TABLE OF CONTENTS

B. Project 2021-04 Modifications to PRC-002-2 Disturbance Monitoring.....	16
C. Project 2020-02 Modifications to PRC-024 (Generator Ride-through)	17
D. Project 2023-02 Analysis and Mitigation of BES Inverter-Based Resource Performance Issues.....	18
VI. JUSTIFICATION FOR APPROVAL: PROPOSED RELIABILITY STANDARD PRC-029-1	19

- A-1 Proposed Reliability Standard PRC-024-4 – Clean
- A-2 Proposed Reliability Standard PRC-024-4 - Redline
- A-3 Proposed Reliability Standard PRC-029-1

Figure 1: Voltage Ride-Through Requirements for AC-Connected Wind Facilities

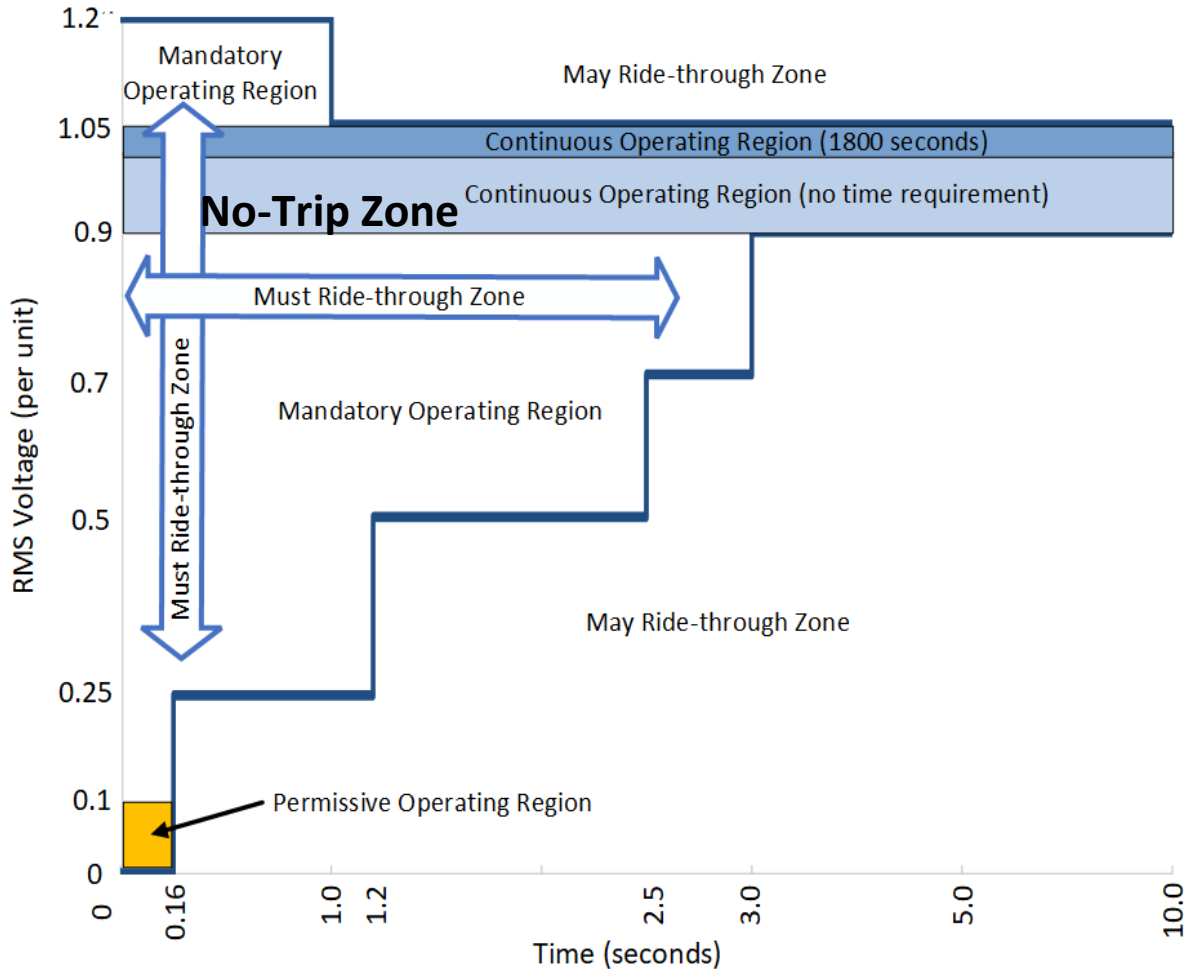
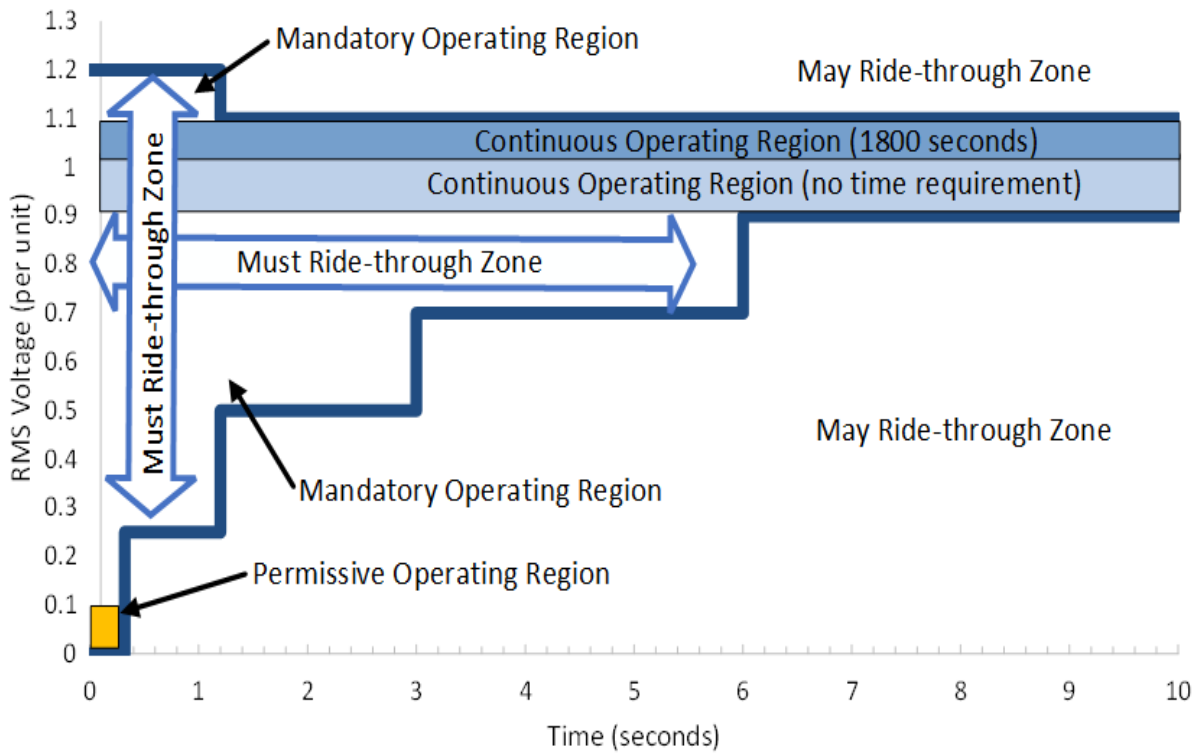
The SRC recommends that the SDT to review and align the data in **Attachment 1** to ensure that the data in Tables 1 and 2 aligns with what is shown in Figures 1 and 2. Currently, the graphs in Figures 1 and 2 do not match what is indicated in the Tables. For example, rows 1-3 in Tables 1 and 2 are identical, yet Figure 2 does not match Figure 1 by indicating a Voltage Ride-Through Requirement of 1.0.

There is a discrepancy between the definition of the Term “Mandatory Operating Region” which states “≤ 1.2 per unit” and Table 1/Figure 1 or Table 2/Figure 2 which state “≥1.200” per unit “N/A”. Please clarify if Table 1/Figure 1 and Table 2/Figure 2 should state “>1200” or if the definition of the Term “Mandatory Operating Region” should state “<1.2 per unit”.

Please clarify Figure 1 and Figure 2 to clearly show the “Continuous Operating Region”, “Mandatory Operating Region”, and “Permissive Operating Region”, along with requirements beyond 10 seconds.

R1/R2: Recommend that Attachment 1 have a chart to include the Continuous Operation Region, Mandatory Operation Region, and Permissive Operation Region or have those regions specified on existing Voltage Ride-through Requirements Figure 1 and Figure 2.

Figure 3: PRC-029 Frequency Ride-Through Requirements

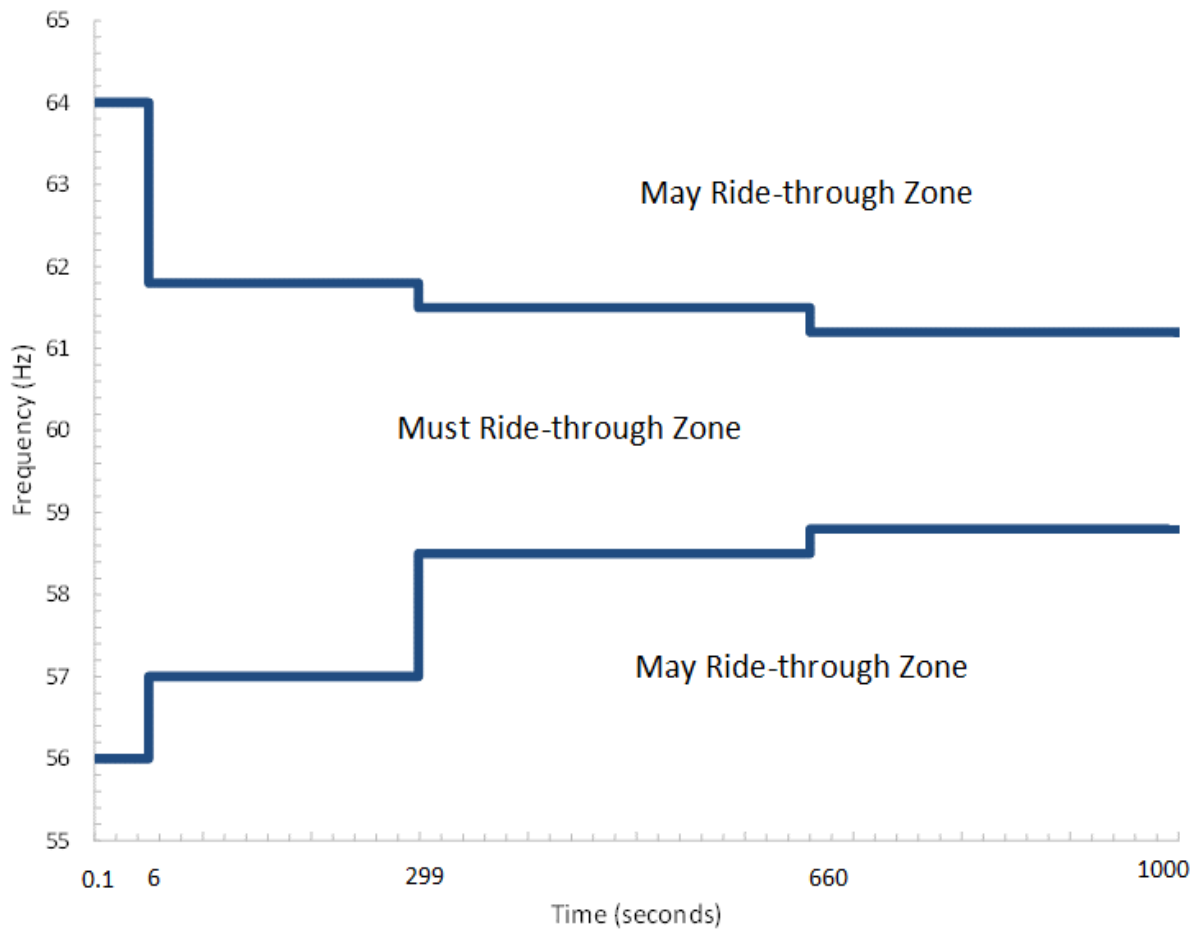
Duke Energy also recommends, if not already considered, to verify with OEMs that the inverters can satisfy Att 2. Figure 3 does not align with IEEE 2800 Figure 14; again, making compliance with both requirements more complicated.
